## DETERMINATION OF NON-SIGNIFICANCE

**City of Bellevue  
Development Services Department  
Land Use Staff Report**

Proposal Name: Lake Hills Shopping Center

File Number: 06-116811-LD

**SITE PLAN** (PHASE - I)

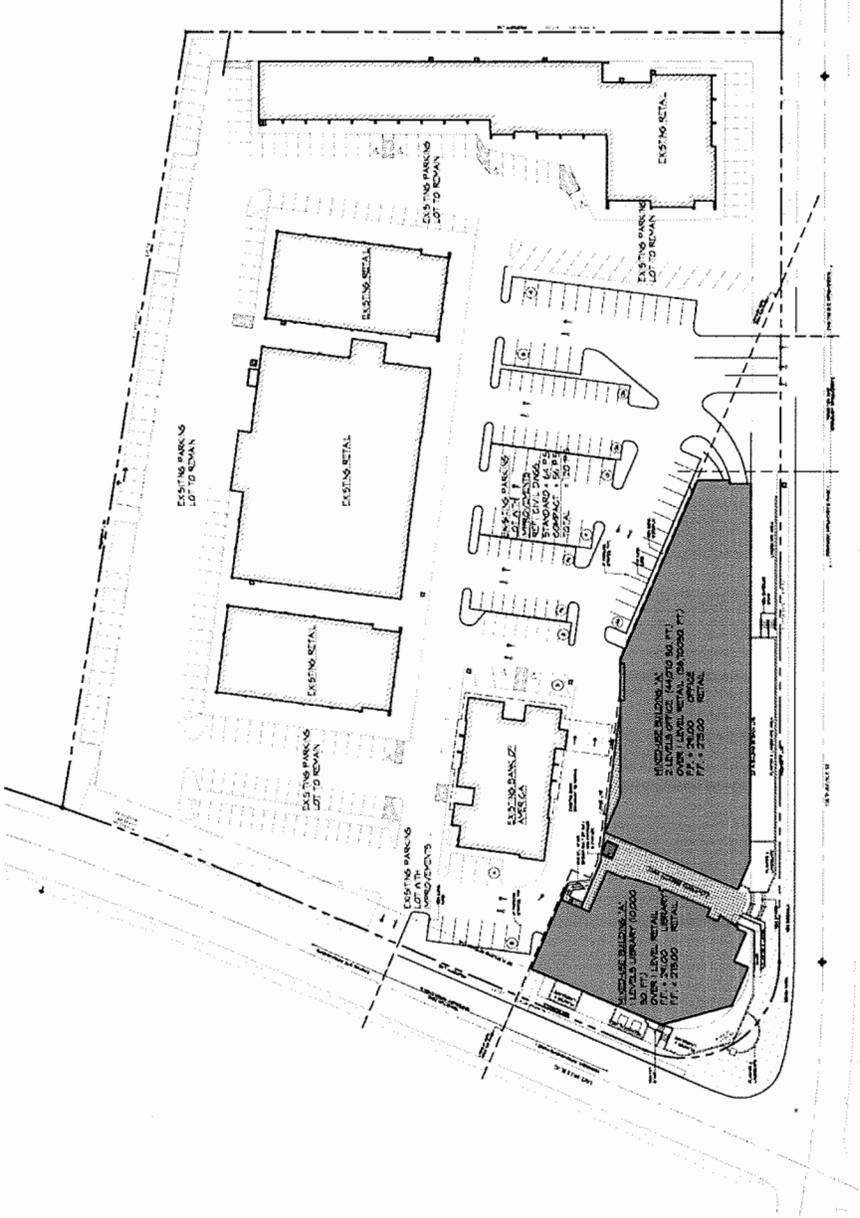
1. Landscape buffer between the project and single family homes to the west was expanded from 20 feet to 30 feet, with denser vegetation to strengthen the visual barrier.
2. Parking area reconfigured to improve vehicular access and circulation.
3. Parking area landscape zones reconfigured to accommodate special pedestrian-oriented events such as a farmer's market or festival.
4. Pedestrian walkway along the duplex buildings modified to accommodate emergency vehicles.
5. Pedestrian pavement markings improved to enhance walkability throughout the site.
6. The drive-thru concept for potential bank use has been removed and a more pedestrian-friendly site design results.
7. Streetlights located and coordinated with street trees and driveways.

**SERVICE SITE PLAN** (BASELINE & ALTERNATE)  
 30 SEPTEMBER 08 DR SUBMITTAL

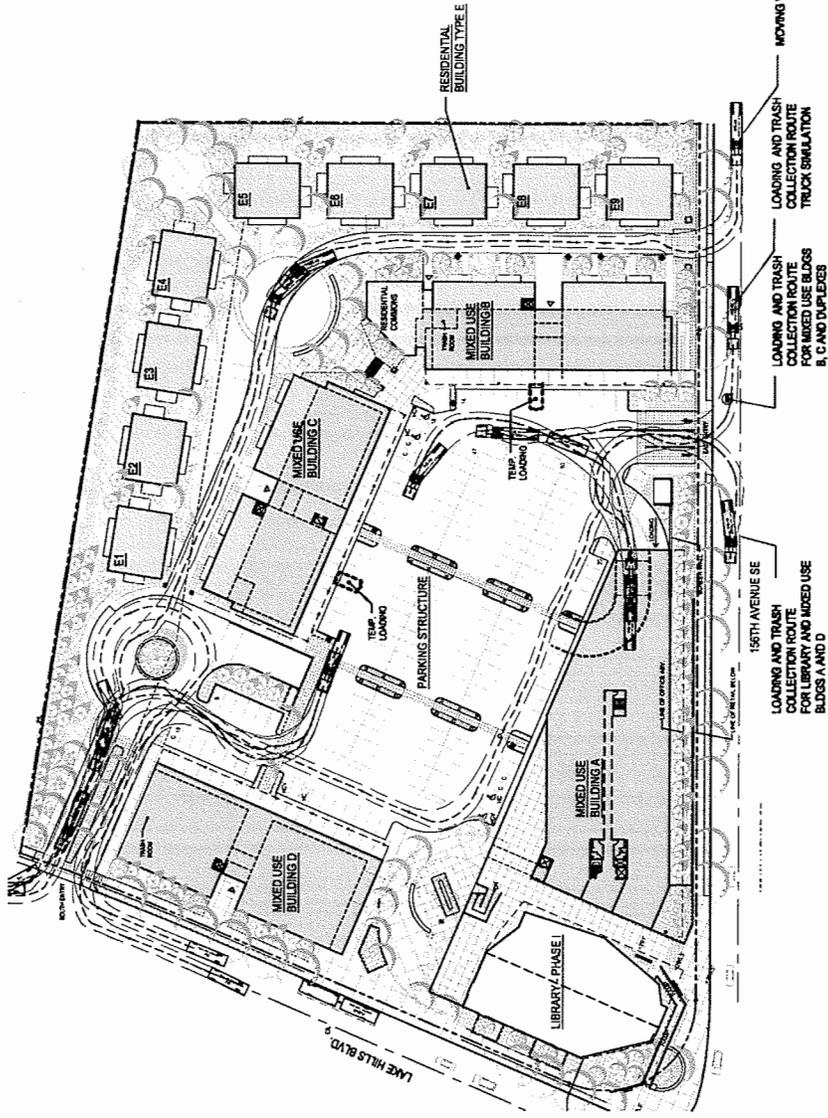
A solid waste and collection system for the project is detailed on Sheet 16 (Service Site Plan) of the Design Review Submittal in conformance with code requirements (LUC 20.20.725), and a condition of approval is included in section X of this report requiring coordination with Allied Waste on provision of garbage and recycling facilities.
